DRAINAGE AND TRANSPORTATION INFORMATION SHEET

PROJECT TITLE: NEW TRAINING/STORAGE FACILITY ZONE MAP/DRG. FILE # L-18-Z
DRB#: _____ EPC#: _____ WORK ORDER#: _____

**RE: New Training & Storage Facility
Engineers Stamp Date 06/12/15 (L18D074)**

Re: New Training and Storage Facility
421 Arizona St. SE
Grading and Drainage Plan
Engineer's Stamped dated 6-12-2015 (L18D074)

B1 BASIN MAP

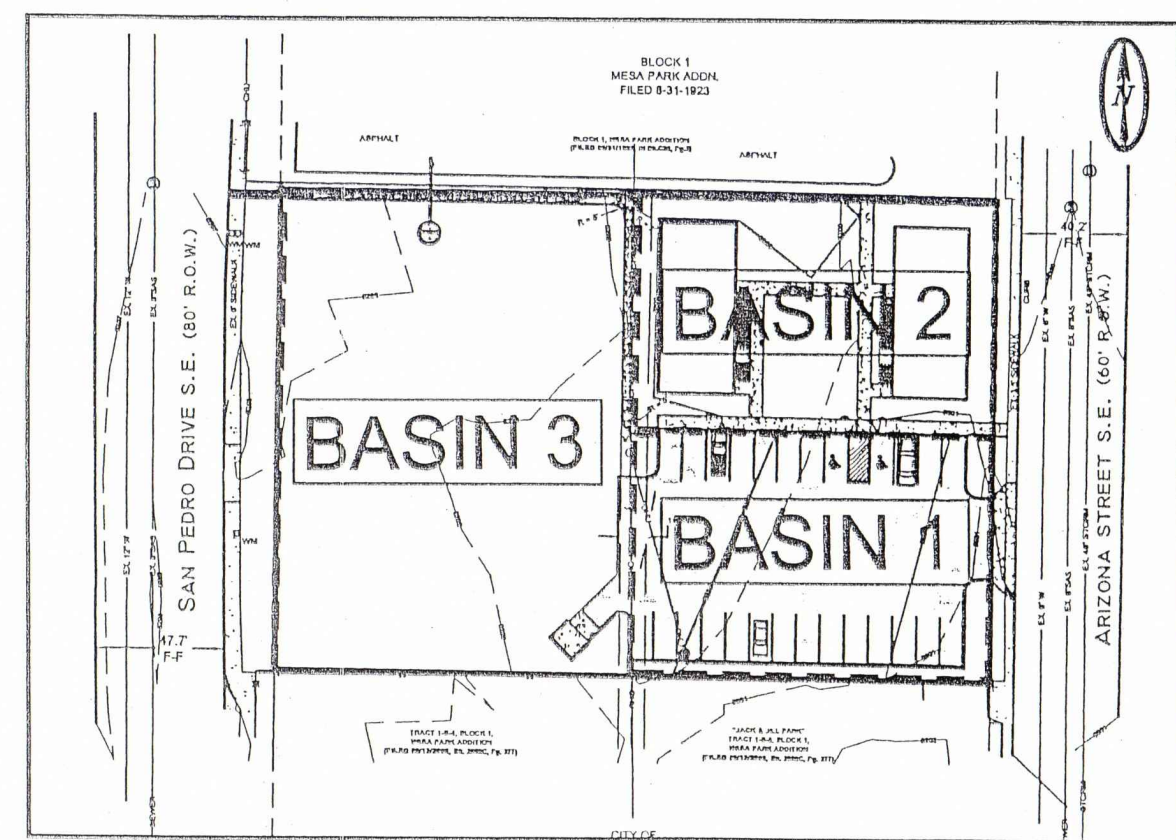
6. Provide a basin map of the entire area.

A basin map of the entire area has been provided on sheet C-100 as requested.

C-102

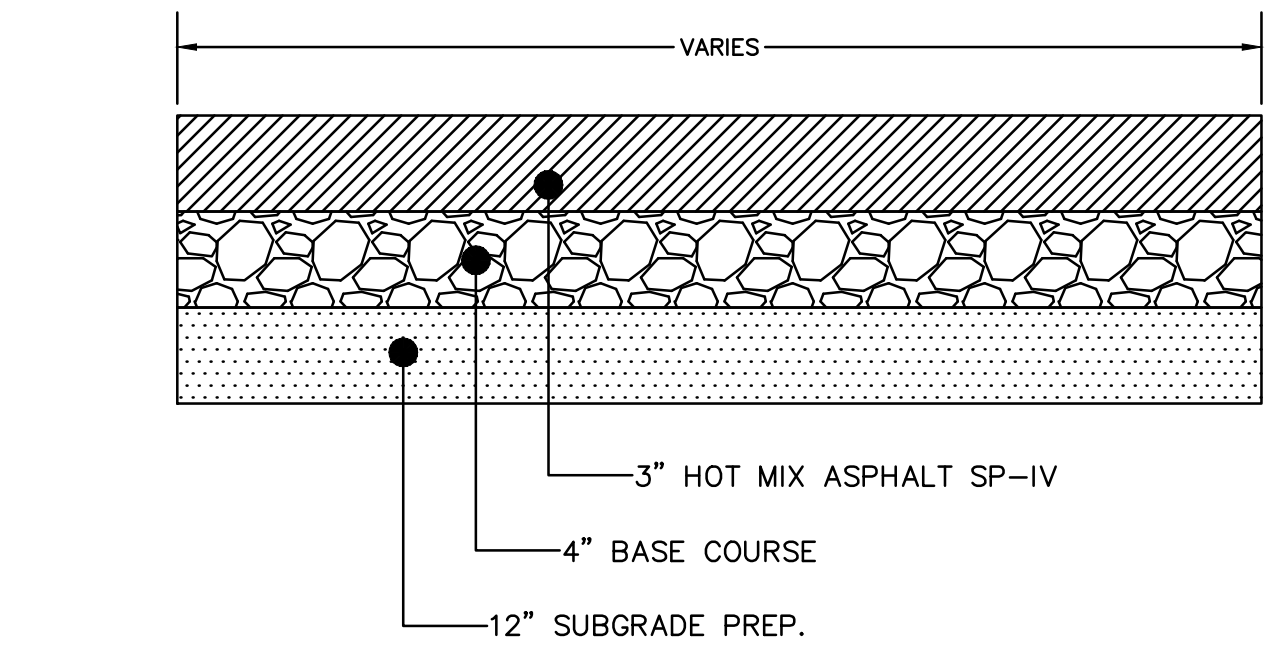
2. Provide the type of surface in the south area. A look at the aerial map shows pavement. How will the flows exit this area?
The area in question is actually dirt/base course as it stands today. The flows will exist through a swale which we have added on sheet C-102. The new swale will begin near the east edge to the south of the property and run west then head northeast around the paved drive area and northwest to the first flush pond on the west side.

D5 **TYPICAL POND SECTION DETAIL**
SCALE: NOT TO SCALE

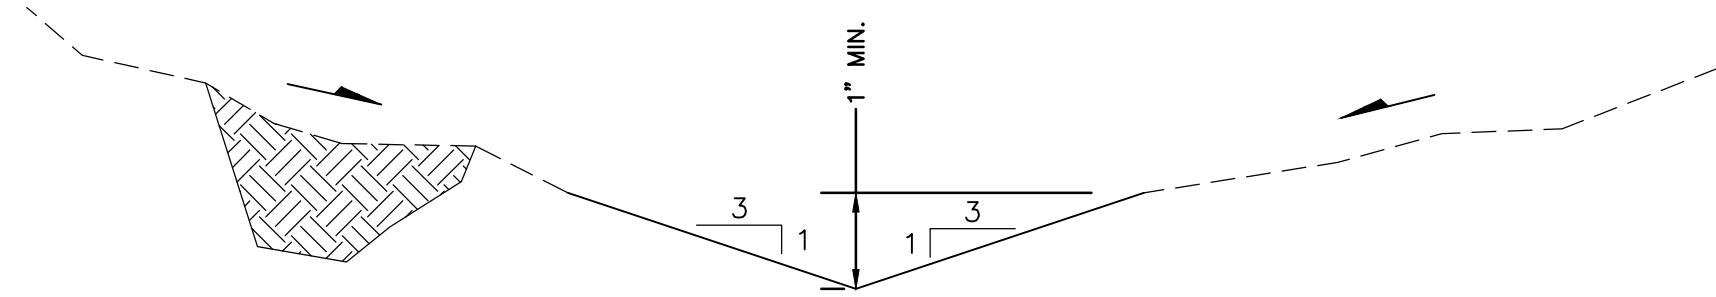
5. Sheet C-501 shows a typical pond section with a berm. Where is this berm located? If on the east side of the pond, how will the concrete channels enter the pond?

The berm has been removed from the detail on sheet C-501. The flows will be able to enter the pond through the concrete channels.
